# Environmental Planning Commission

Agenda Number: 03  
Project Number: 1010999  
Case #: 16EPC-40050  
March 09, 2016

## Staff Report

<b>Agent</b>	Clint Wilsey, 66Architect, LLC
<b>Applicant</b>	2 Development, LLC
<b>Request</b>	<b>Site Development Plan for Building Permit</b>
<b>Legal Description</b>	Lot C-4-A-1, Seven Bar Ranch
<b>Location</b>	NM Highway 528, between Ellison Dr. NW and Cottonwood Dr. NW
<b>Size</b>	Approximately 1.2 acres
<b>Existing Zoning</b>	SU-1 for IP Uses
<b>Proposed Zoning</b>	No change

LANDSCAPE PLAN

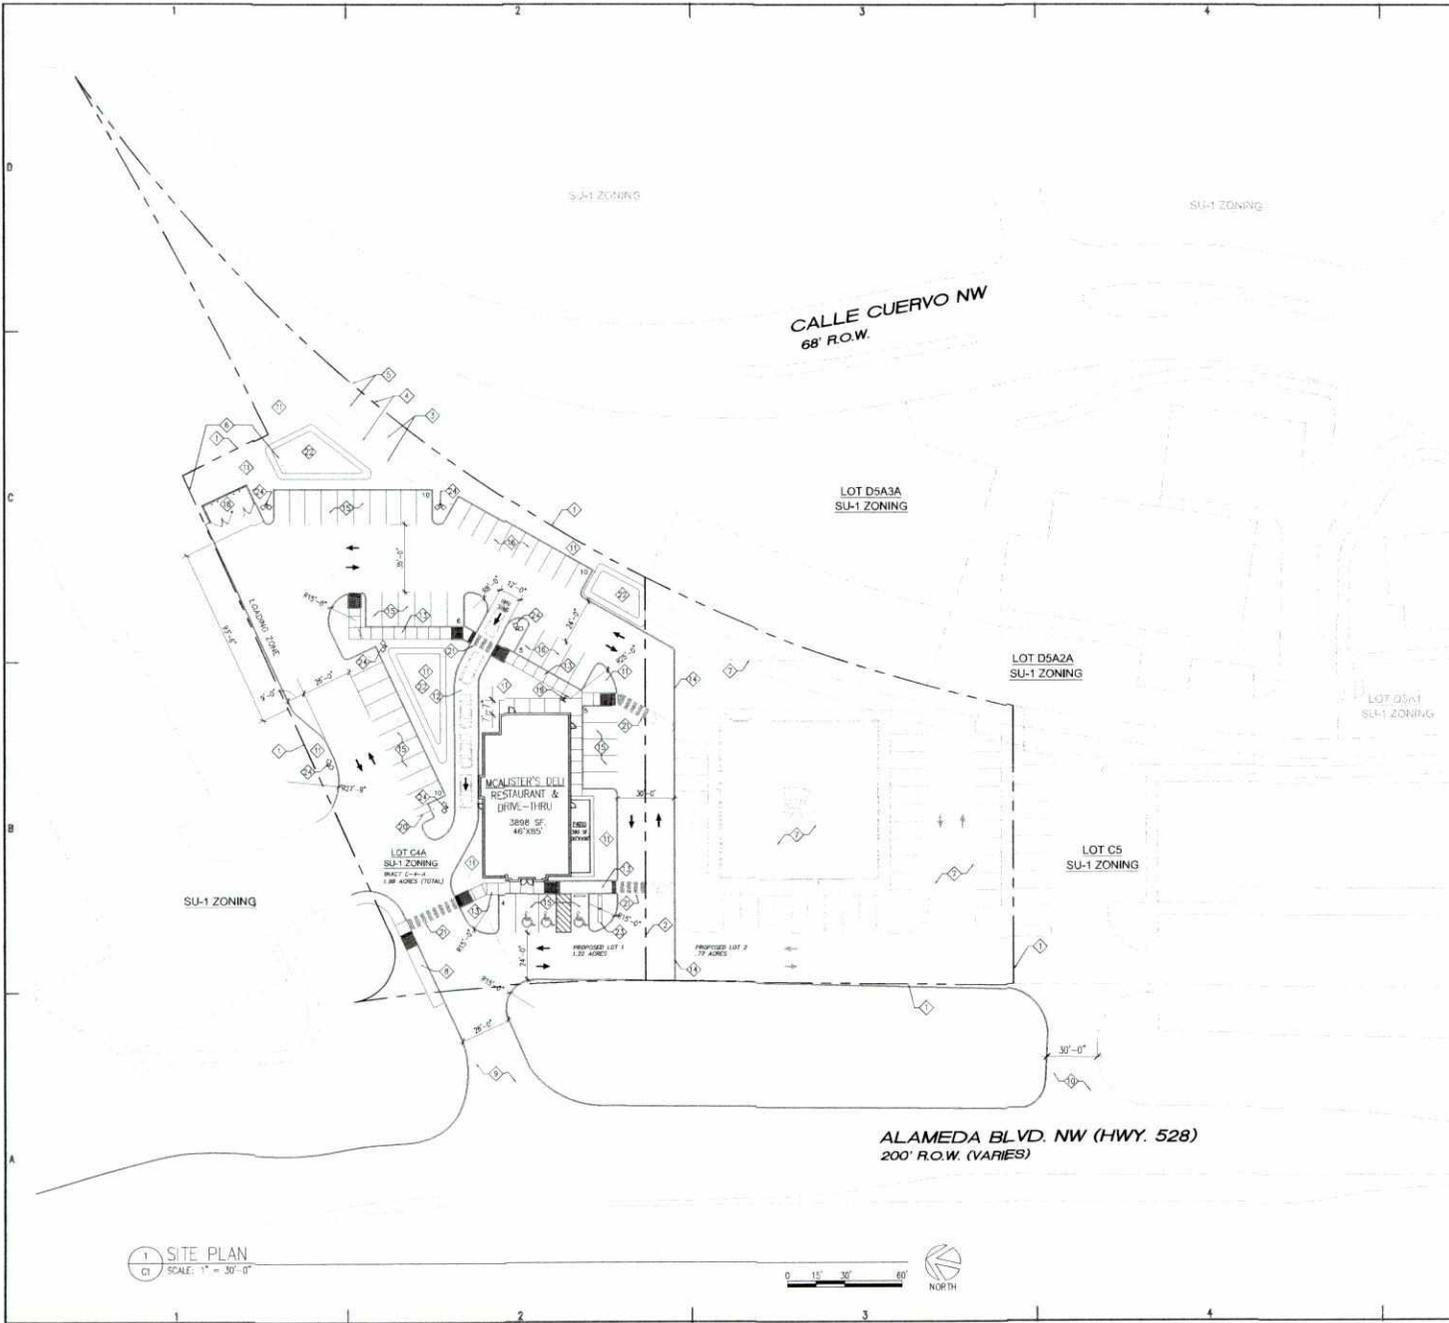
- 1) Must meet C.O.A minimum requirements for bollards in enclosure
- 2) Drain specs must also be shown on site plan that meet C.O.A minimum requirements
- 3) Sheet LS-101 shows Bradford Pear creating an overhang over enclosure, which will cause a hindrance to refuse driver. Bradford pear will have to be placed in another location.
